ECE/TRANS/WP.29/GRSG/2009/19  
10 August 2009

**REGULATION No. 46  
(Devices for indirect vision)**

Proposal for draft amendments to Regulation No. 46

Submitted by the expert from the United Kingdom \*/

**Figure 8c - Required field of vision for passenger side"**

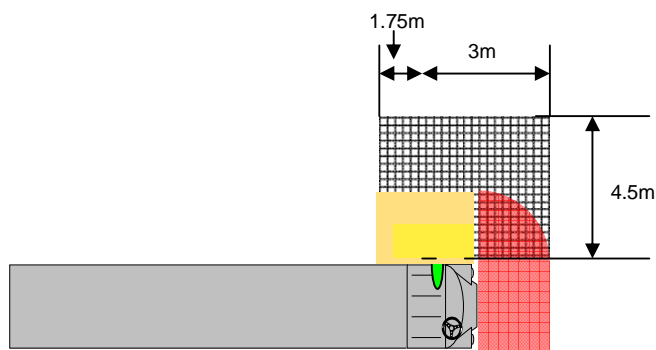
Insert new paragraphs 15.2.4.5.6. to 15.2.4.5.9.( including new Figure 8c), to read:

- "15.2.4.5.6. on the passenger side only, the field of vision described in paragraphs 15.2.4.5.1. to 15.2.4.5.5. shall be extended by means of any device, or combination of devices, such that the driver can see a flat horizontal portion of the road along the side of the vehicle, bounded by the vertical planes defined in Figure 8c.**
- 15.2.4.5.7. in the transverse direction, the parallel plane passing at a distance of 4.5 m in front of the plane mentioned in paragraph 15.2.4.5.1.**
- 15.2.4.5.8. to the rear, the plane parallel to the vertical plane passing through the driver's ocular points and situated at a distance of 1.75 m behind that plane.**
- 15.2.4.5.9. to the front, the plane parallel to the vertical plane passing through the driver's ocular points and situated at a distance of 3 m in front of that plane.**

The United Kingdom would like to permit the use of any device, or combination of devices, to extend the field of vision (FoV) of the class V device on the passenger side of N<sub>2</sub> and N<sub>3</sub> vehicles. The reason for doing so is to reduce the occurrence of side-swipe incidents when these large vehicles are changing lanes on motorways and to better enable the driver to see vulnerable road users when manoeuvring or turning at junctions. The alternative would be to improve the driver's direct FoV, which may be much more difficult to achieve.

Extending the FoV requirement on the passenger side from an area measuring 2.75 m (long) x 2 m (out from the cab) to an area 4.75 m (long) x 4.5 m (out from the cab) would fully cover the front edge of the class IV device FoV and overlap a class VI device FoV (if fitted). This would probably be beyond the ability of a mirror system but may be within the capabilities of an additional camera/monitor system, vision support (radar sensing) system or other alternative solution.
